# Mechanical Permit Set - Equipment Replacement Puyallup School District Central Kitchen Facility

**CENTRAL KITCHEN FACILITY**  
3607 17th St SW Puyallup, Washington  
SHEET TITLE: **MECHANICAL/ELECTRICAL  
SITE PLAN**  
SHEET NO.: **ME1.0**  
PROJECT NO.: **7351**

**CENTRAL KITCHEN FACILITY**  
3607 17th St SW Puyallup, Washington  
SHEET TITLE  
**1/4" KITCHEN PLUMBING  
PLAN B**

TITLE: PUYALLUP - QUOTE 24092 REV 8  FLOOR PLAN		UNLESS OTHERWISE SPECIFIED:	MODEL NUMBER	REV
		DIMENSIONS ARE IN INCHES AND ARE USED FOR REFERENCE ONLY.  ON-SITE VERIFICATION MAY BE REQUIRED.  DO NOT SCALE.	FLOOR PLAN	A
DATE: 3/14/2025	DRAWN BY: T. AFFELDT			SHEET: 1 OF 3

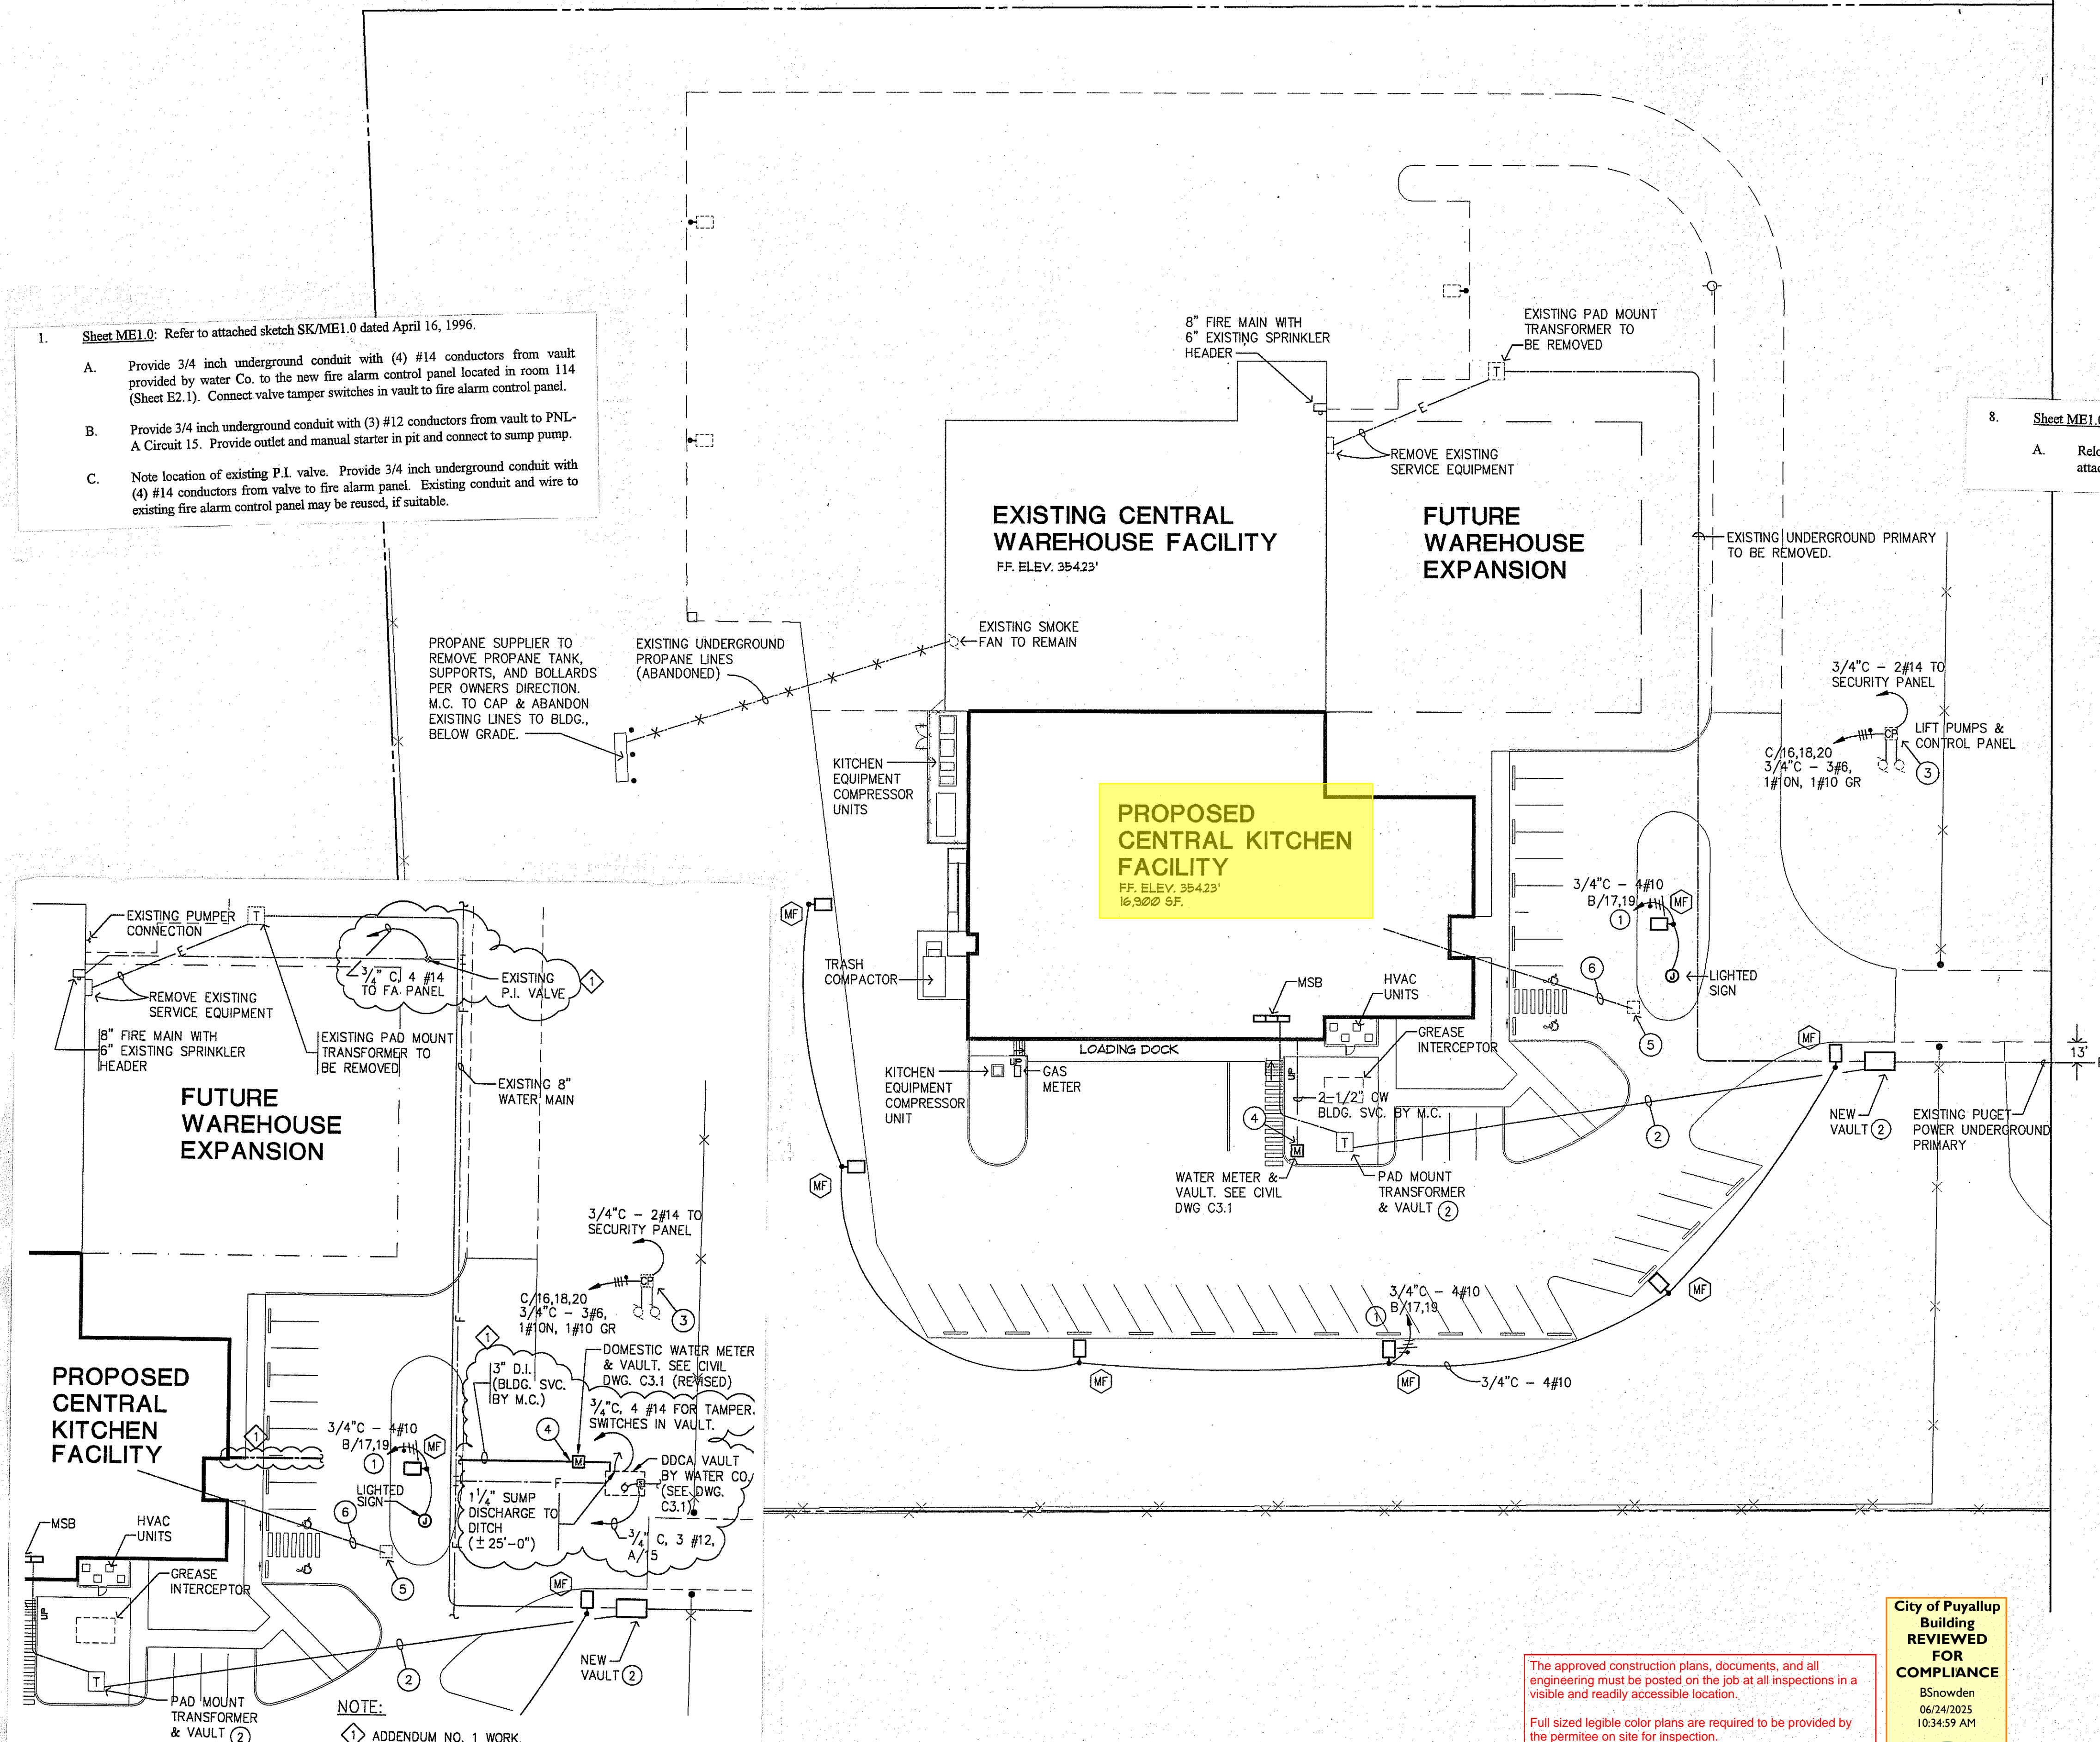
1. Sheet ME1.0: Refer to attached sketch SK/ME1.0 dated April 16, 1996.

- Provide 3/4 inch underground conduit with (4) #14 conductors from vault provided by water Co. to the new fire alarm control panel located in room 114 (Sheet E2.1). Connect valve tamper switches in vault to fire alarm control panel.
- Provide 3/4 inch underground conduit with (3) #12 conductors from vault to PNL-A Circuit 15. Provide outlet and manual starter in pit and connect to sump pump.
- Note location of existing P.I. valve. Provide 3/4 inch underground conduit with (4) #14 conductors from valve to fire alarm panel. Existing conduit and wire to existing fire alarm control panel may be reused, if suitable.

8. Sheet ME1.0

- Relocate water meter and CW building service to new location per partial Site Plan attached sketch SK/ME1.0.

SHEET NO.:  
**A2.1**  
PROJECT NO.:  
**7351**

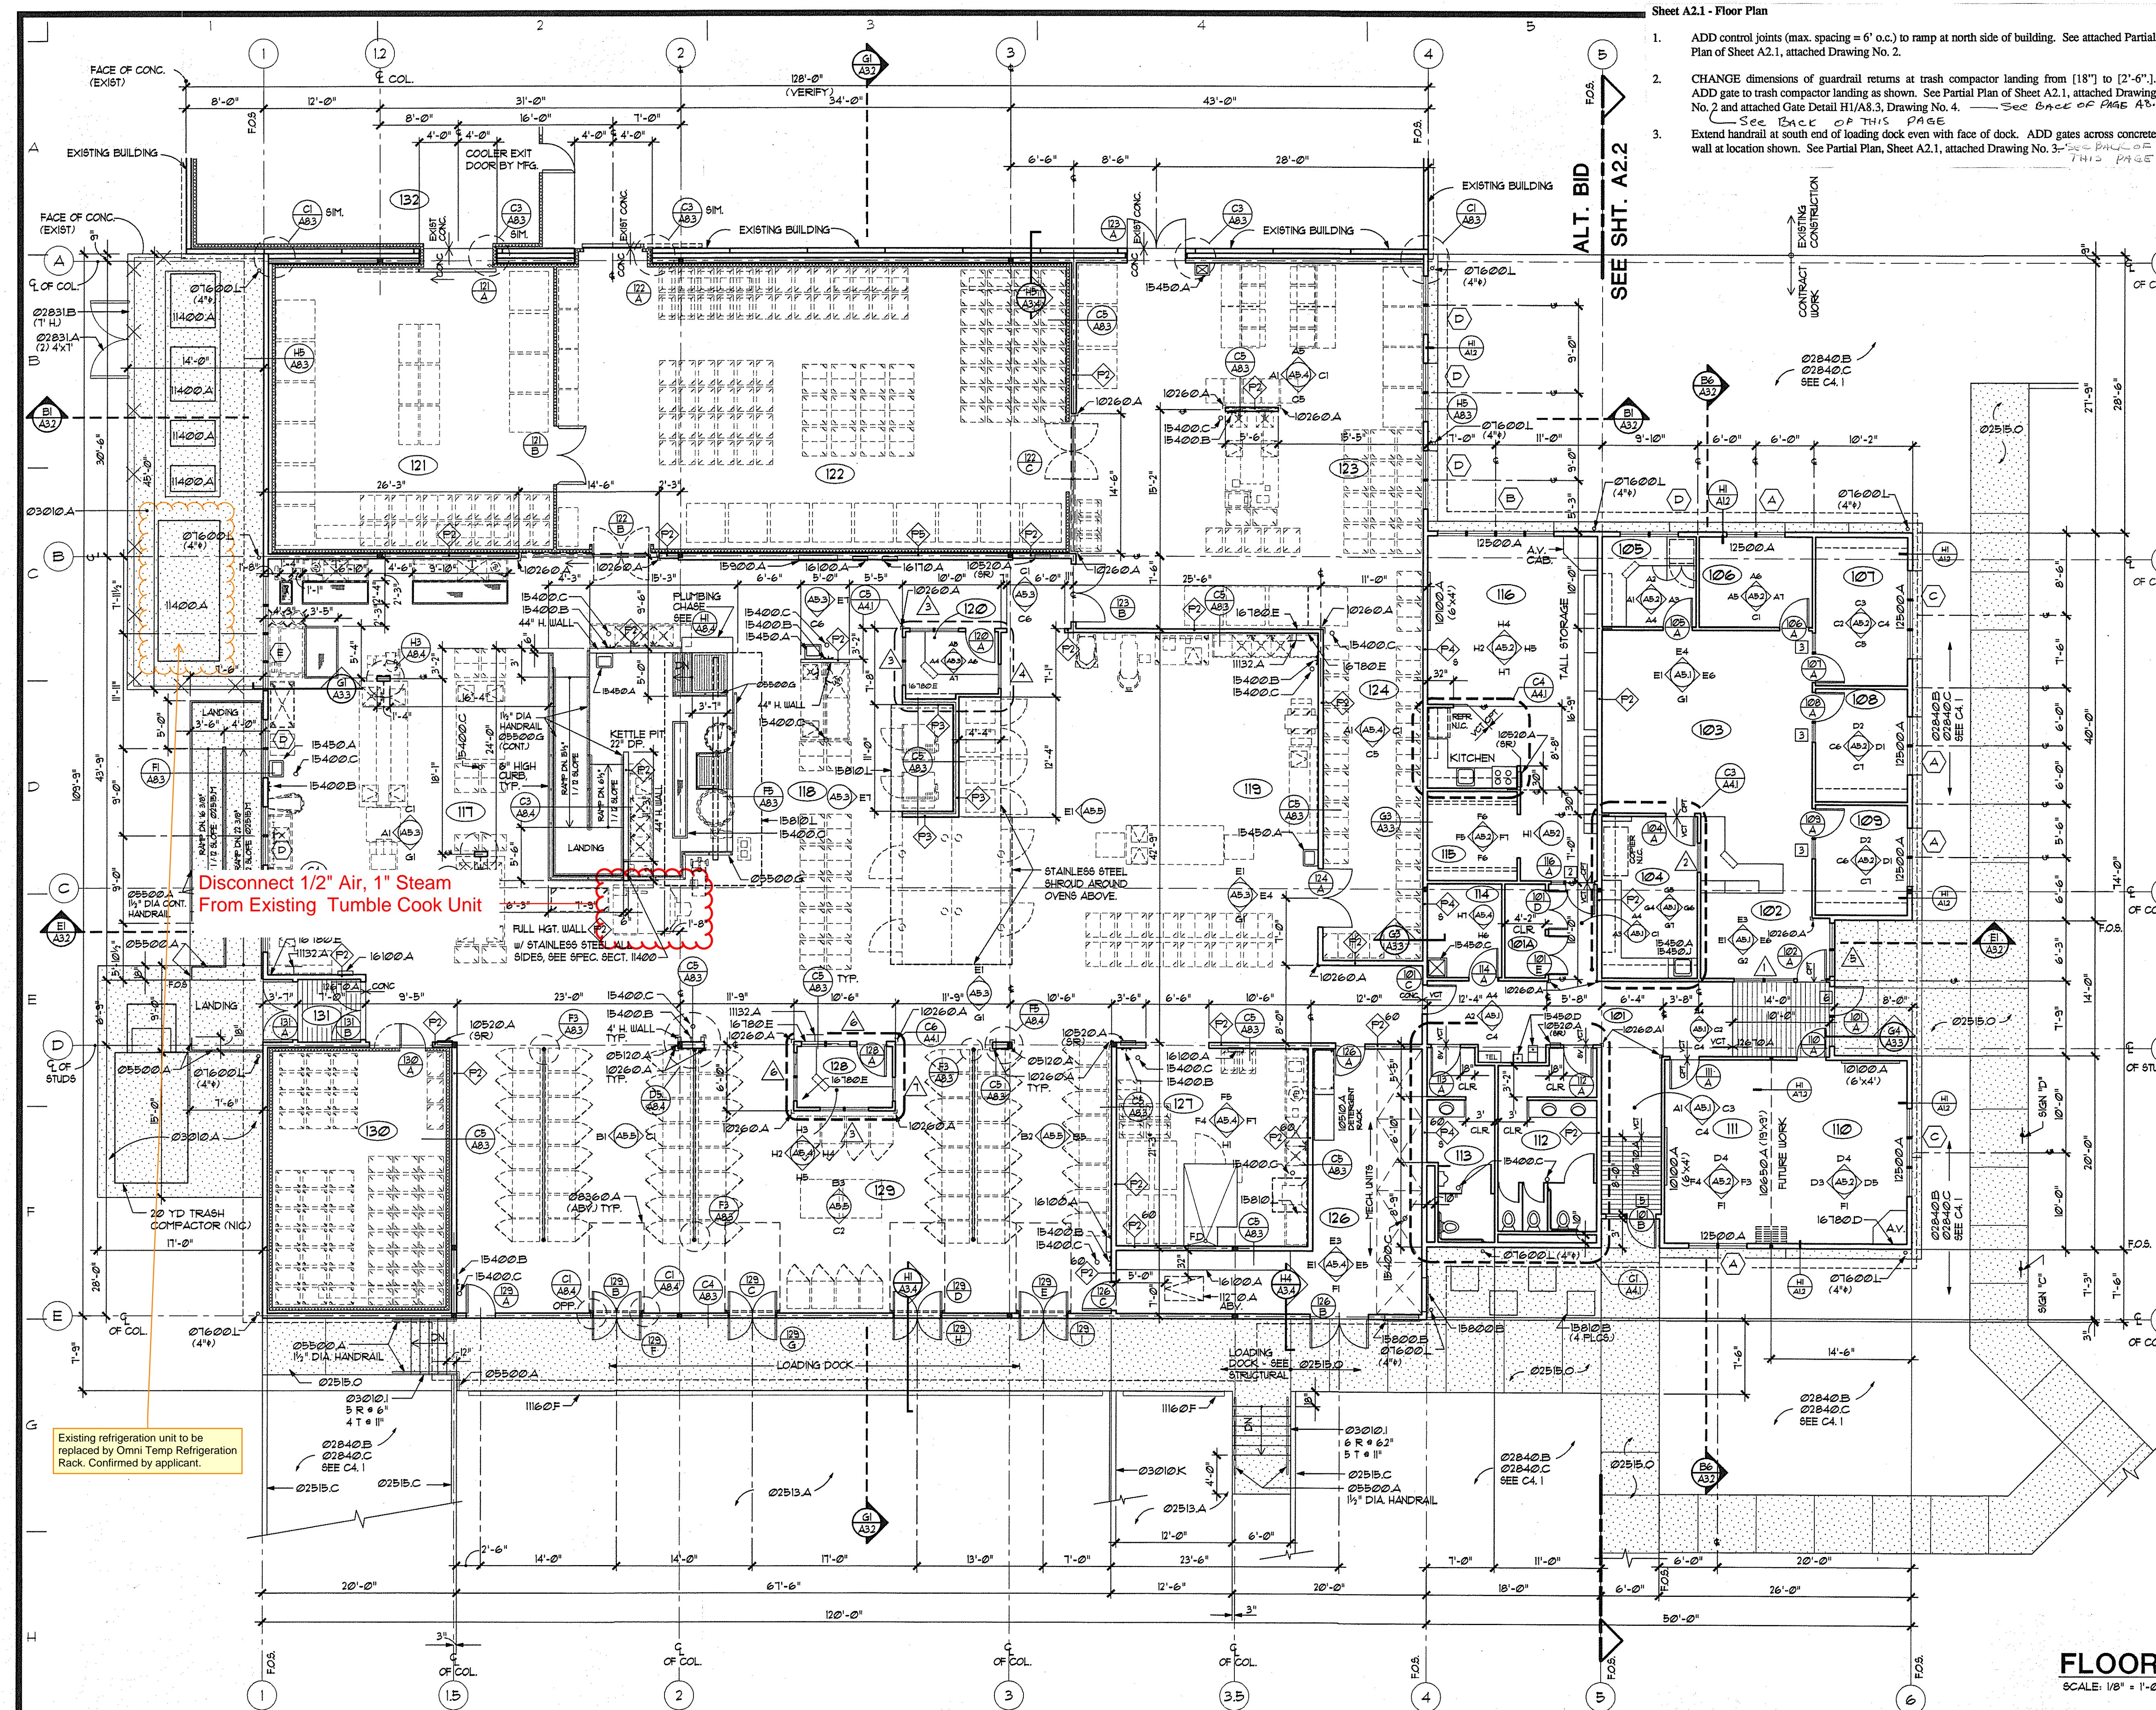
- Sheet A2.1 - Floor Plan
- ADD control joints (max. spacing = 6' o.c.) to ramp at north side of building. See attached Partial Plan of Sheet A2.1, attached Drawing No. 2.
  - CHANGE dimensions of guardrail returns at trash compactor landing from [18"] to [2'-6"]. ADD gate to trash compactor landing as shown. See Partial Plan of Sheet A2.1, attached Drawing No. 2 and attached Gate Detail H1/A8.3, Drawing No. 4. See BACK OF THIS PAGE
  - Extend handrail at south end of loading dock even with face of dock. ADD gates across concrete wall at location shown. See Partial Plan, Sheet A2.1, attached Drawing No. 3. See BACK OF THIS PAGE

## KITCHEN PLUMBING PLAN B

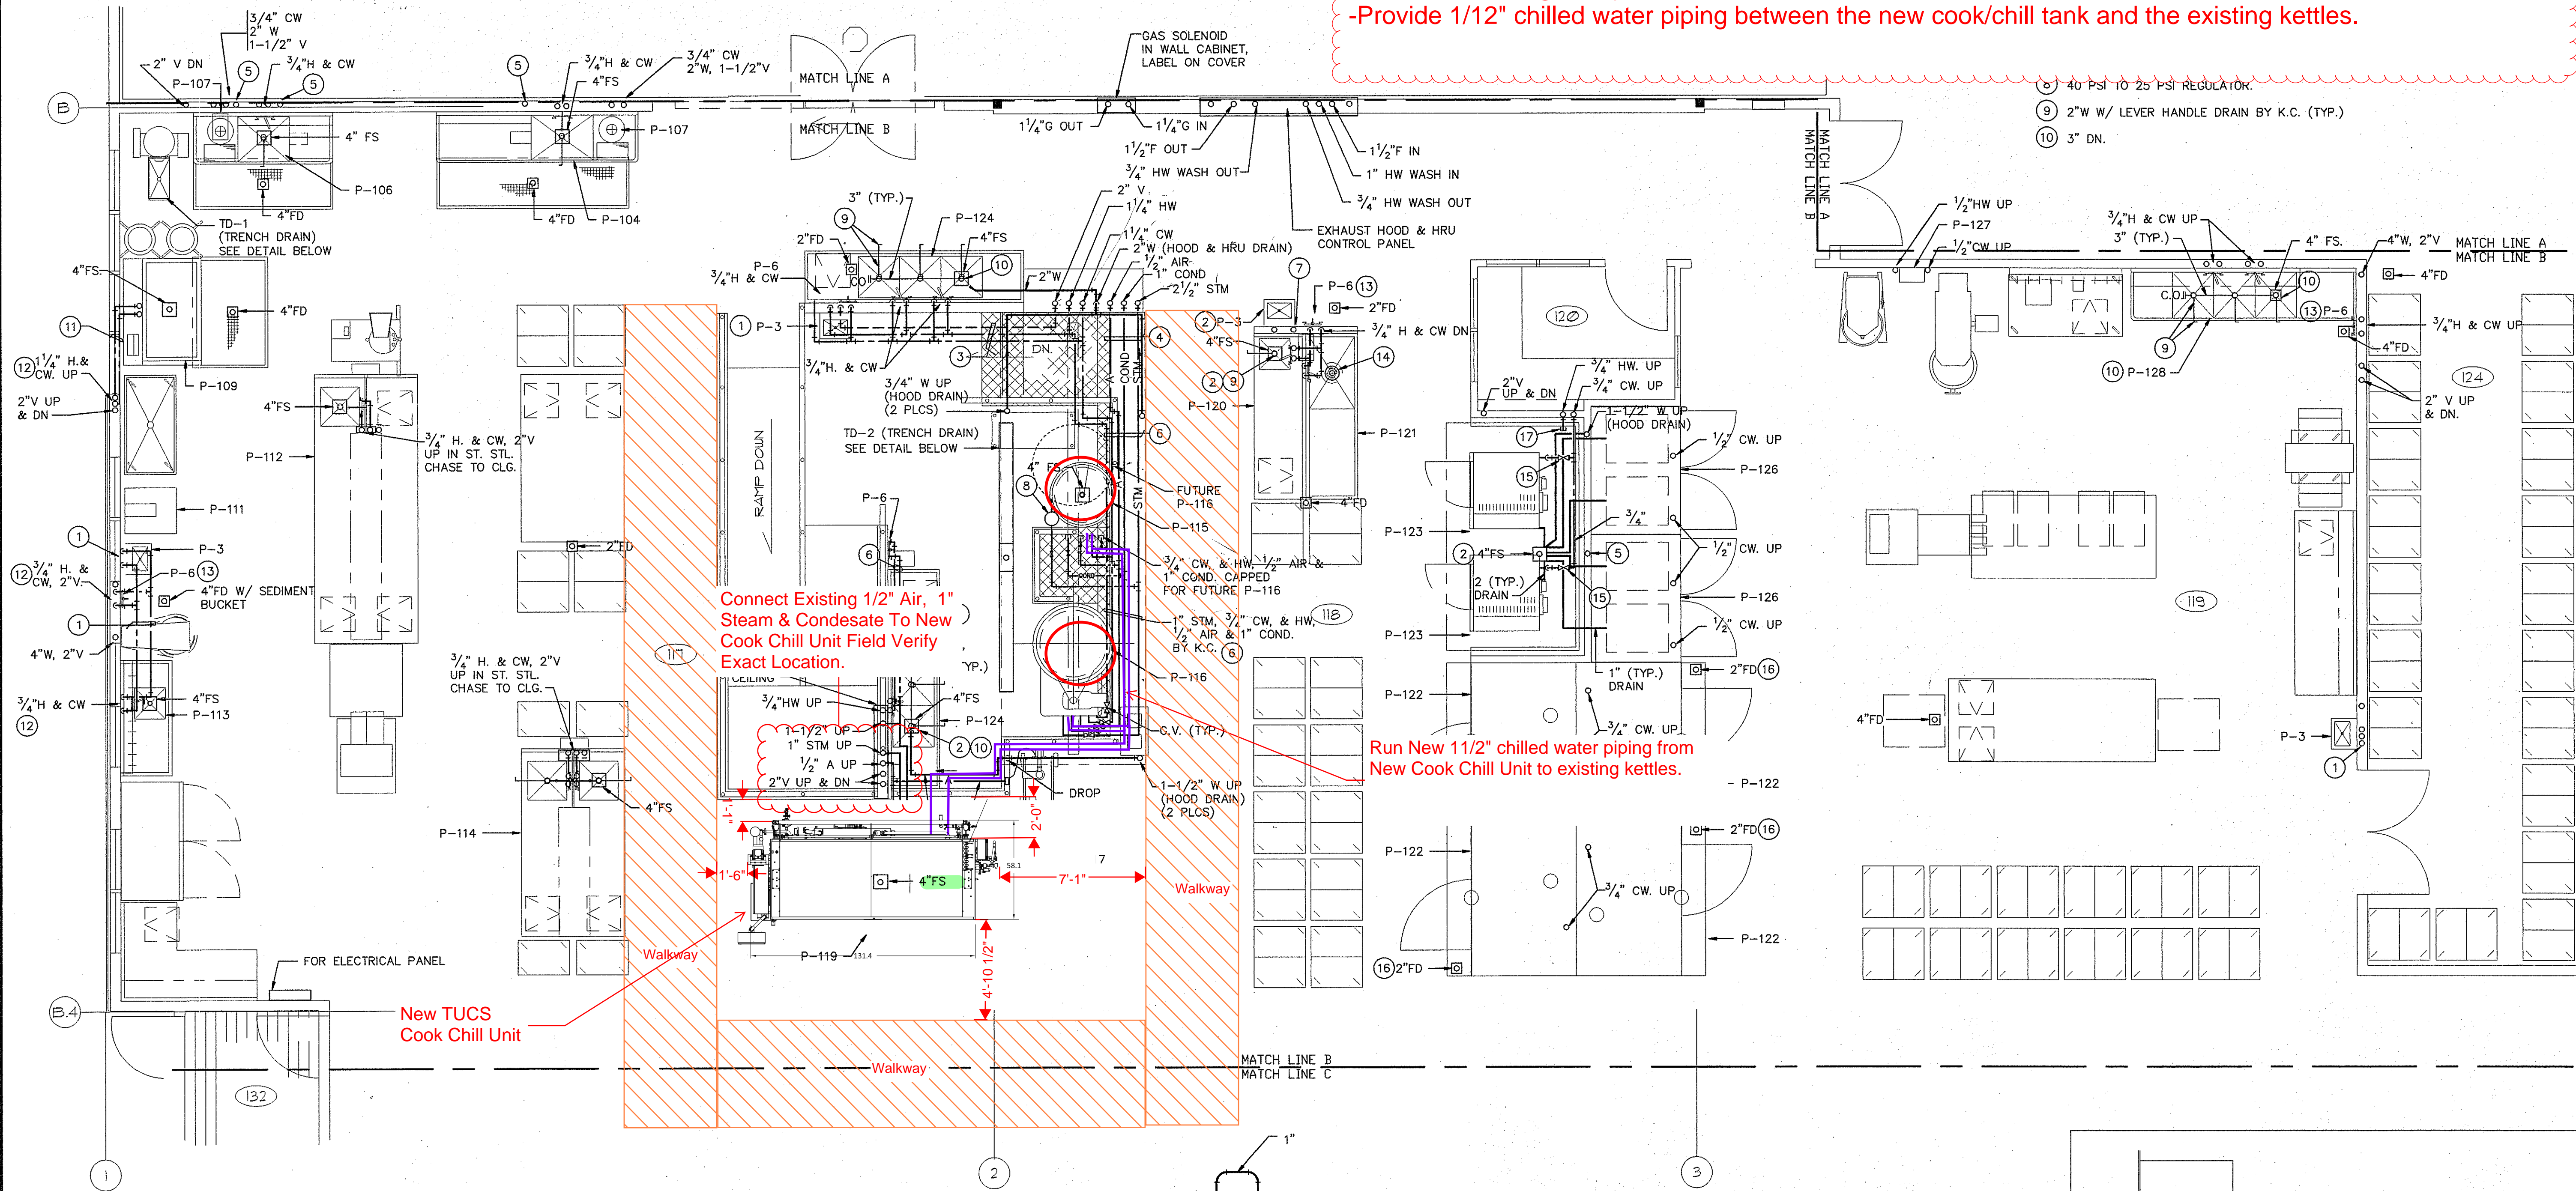
- Disconnect existing Compressed Air, Steam, Condensate, From Existing Tumble Chill Unit
- Connect Existing Compressed Air, Steam & Condensate to New Cook Chill Unit
- Provide 1/12" chilled water piping between the new cook/chill tank and the existing kettles.

(4) New refrigeration lines utilizing existing piping pathway. New lines will be 1-3/8 & 1/2 copper refrigeration lines with Armaflex insulation. Red-lines provided by, and approved by the Applicant.
